**SSD-55266460 – 45-57 Moxon Road Multi-Level Warehouse
Submission to the State Significant Development Application – Canterbury Bankstown
City Council**

Attachment A - Council submission to State Significant Development Application

Figure 1: Aerial demonstrating the extent of the Coastal Area Affection in relation to the subject site as identified under the State Environmental Planning Policy (Resilience and Hazards) 2021 (Source: Council's Mapping System)

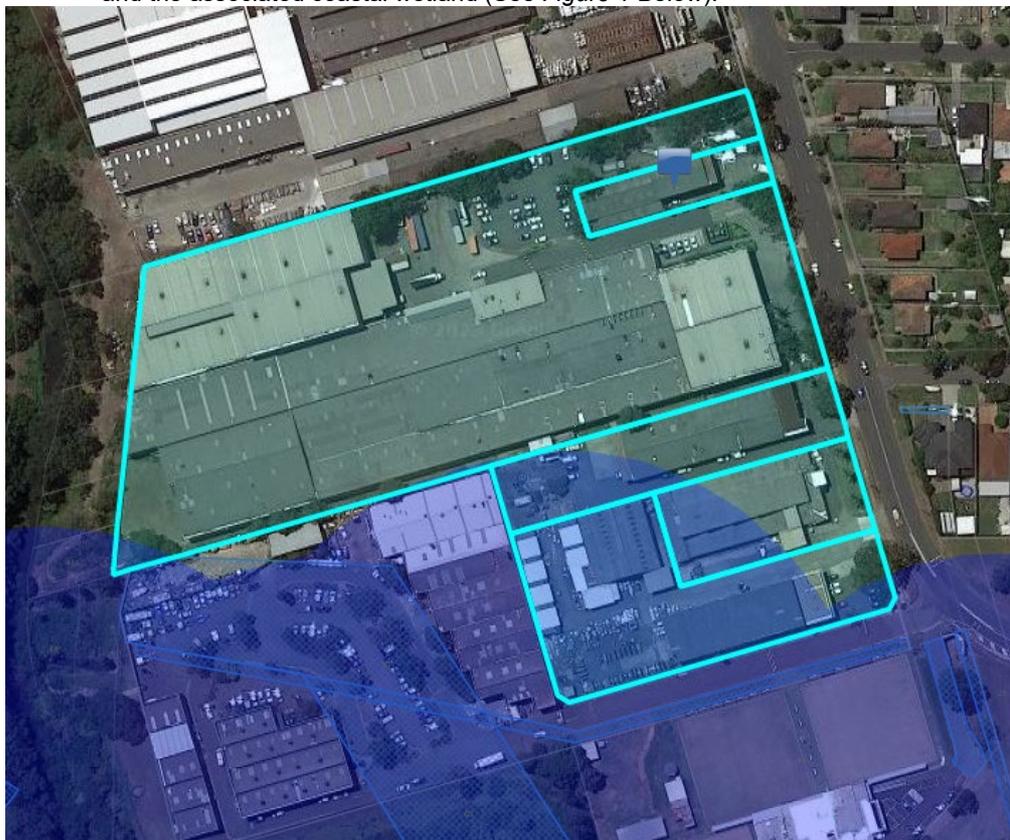
Issue	Council's comments
Environmental Impacts	<ol style="list-style-type: none">1. It has been noted from previous assessments that many of the trees onsite are Canary Island Date Palms. The Canterbury Bankstown Australian White Ibis Management Plan (2018) states that 207 Canary Island date palms (<i>Phoenix canariensis</i>) are located on the road reserves throughout the City. Of these, 207 palms, 191 are listed as heritage items under the Canterbury Bankstown Local Environmental Plan 2023 and have Conservation Management Strategies in place to promote longevity and conservation. No survey has been undertaken on the number of Canary Island Date Palms located on private property. The palms are thought to have been planted as part of memorial plantings during the early twentieth century through to the interwar period. As such, the heritage significance of the Canary Island Date Palms on site must be assessed by Council's Heritage officer/advisor.2. Council requests that any proposal must make all reasonable efforts to retain native trees, particularly along the northern boundary of the allotment and along Moxon Road Street frontage.3. Any landscape plan would need to include species consistent with Plant Community Type (PCT) 3448 which is part of the Cooks River/Castlereagh Ironbark Forest, particularly along the western portion of the site. Trees required for removal to support the development would need to be replaced at a minimum 3:1 ratio in accordance with Council's Tree Management Manual.4. The EIS must state how the proposal has appropriately avoided and minimised impacts to vegetation and associated habitat onsite. The EIS should also assess the proximity area for coastal wetlands and assess indirect impacts to Salt Pan Creek and the associated coastal wetland (See Figure 1 Below).
